SUBJECT: ISSUANCE OF AMENDMENTS NOS. 184, 184, AND 181 TO FACILITY OPERATING
LICENSES DPR-38, DPR-47, and DPR-55 - OCONEE NUCLEAR STATION,
UNITS 1, 2, AND 3 (TACS 68064/68065/68066)

SAFETY EVALUATION BY THE OFFICE OF NUCLEAR REACTOR REGULATION
RELATED TO AMENDMENT NO. 184 TO FACILITY OPERATING LICENSE DPR-38

OCONEE NUCLEAR STATION, UNITS 1, 2 AND 3

Oconee Nuclear Station
Figure 3.5.2-16

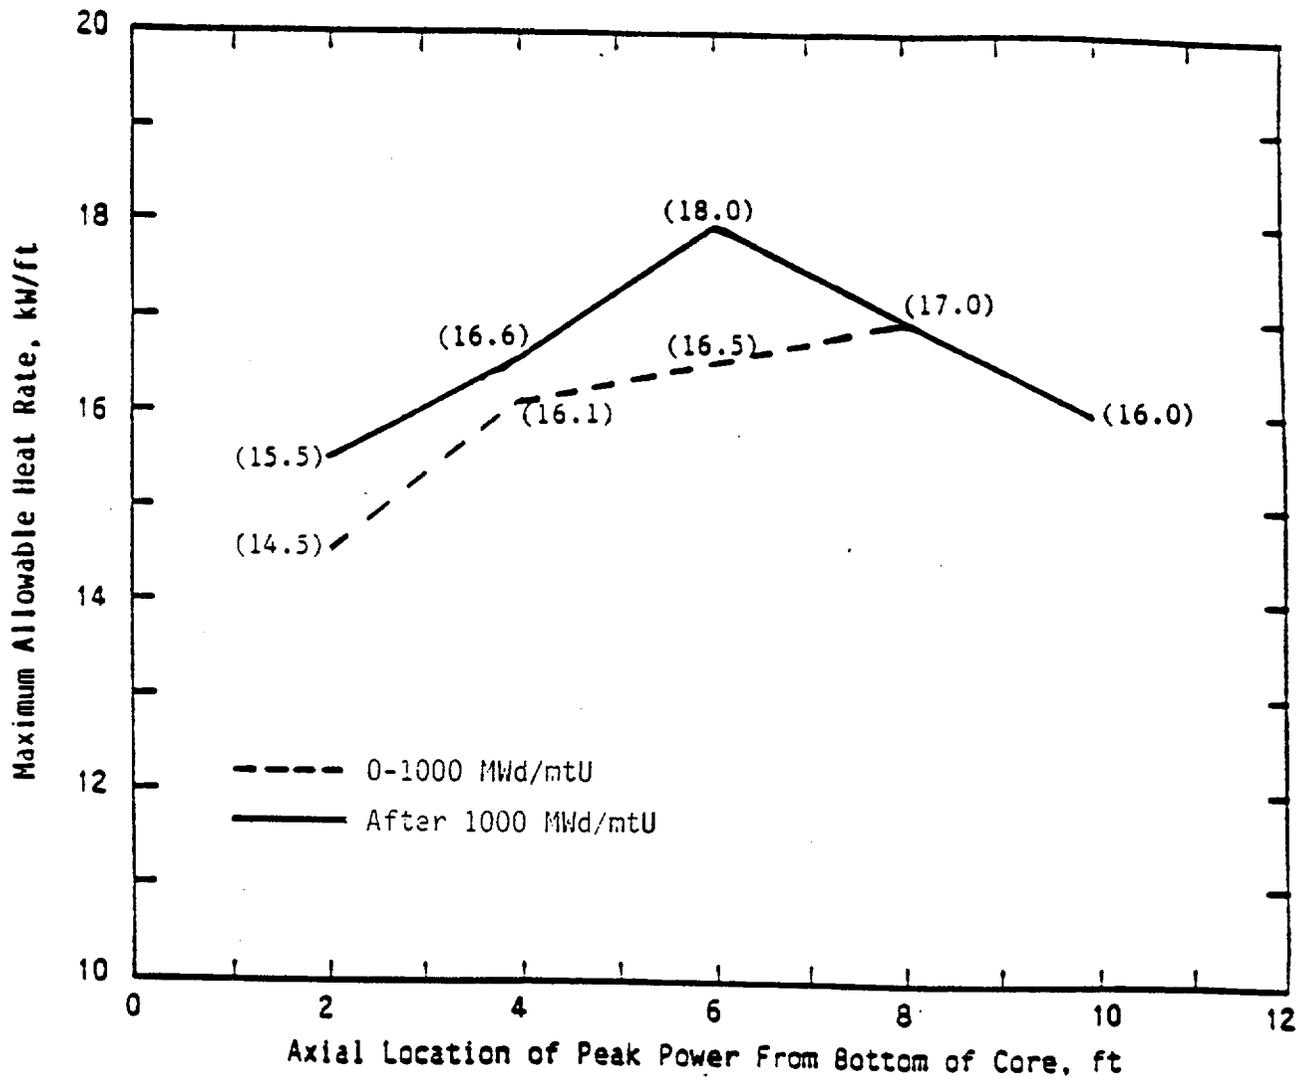
The TSs revised by these amendments allow an increase in the maximum linear heat rate at the 2-foot core level for specified periods of fuel burnup.

By letter dated January 22, 1988 (Ref. 1), Duke Power Company, licensee for the Oconee Nuclear Station (ONS), Units 1, 2, and 3, proposed a revision to Technical Specification (TS) Figure 3.5.2-16 for the loss of coolant accident (LOCA)-Limited Maximum Allowable Linear Heat Rate (LHR). The results of the analysis in BAW-2001P (Ref. 2) were provided in support of a peak power limit increase from 14.0 to 14.5 kW/ft for the 0-1000 megawatt days per metric ton uranium (Mwd/mtU) burnup parameter. A modification was submitted in a letter dated October 9, 1989 (Ref. 3) for the elimination of the 1000-2600 Mwd/mtU burnup parameter. The NRC staff review of the BAW-2001P report was limited to its applicability to the Oconee plant for the increase in LOCA-Limited Maximum Allowable LHR.

The design change made by the licensee was a reduction by 50 psi in the fuel rod pre-pressure, resulting in a reduction of the internal pin pressure during plant operation. The reduced internal pin pressure (1) allows for longer burnup periods (fuel cycles), and (2) delays the time to clad rupture during a LOCA. An evaluation by the licensee indicated that the pin pre-pressure reduction would delay rupture by a time increment equal to a rise in the LHR of .5 kW/ft. The LOCA analysis, therefore, utilized an increased LHR of 14.5 kW/ft, as compared to the current 14.0 kW/ft limit at the 2-foot core elevation for the 0-1000 MWd/mtU burnup parameter.

In a letter dated October 9, 1989 (Ref. 3), the licensee modified their original proposal to eliminate the 1000-2600 MWd/mtU burnup parameter and to have the "after 2600 MWd/mtU" burnup parameter relabeled "after 1000 MWd/mtU." This change is in agreement with the tabulated results in Table 3-2 of the BAW-10104 report (Ref. 5), which was approved by NRC in a letter dated October 12, 1987 (Ref. 10), and is therefore acceptable.

- (1) The reduced pin pressure results in delayed rupture and, consequently, lower peak cladding temperatures for the same LHR.
- (2) The reduced pin pressure maintains lower internal pin pressures for the entire fuel cycle.
- (3) Based on the reanalysis of the 2-foot core elevation LHR, as reported herein, the 2-foot peak power location LOCA LHR limit as shown in TS Figure 3.5.2-16, can be raised from 14.0 kW/ft to 14.5 kW/ft for the 0-1000 MWd/mtU burnup parameter for the Oconee Nuclear Station, Units 1, 2 and 3. Also, the 1000-2600 burnup parameter can be removed because of the results provided in the approved report BAW-1915.
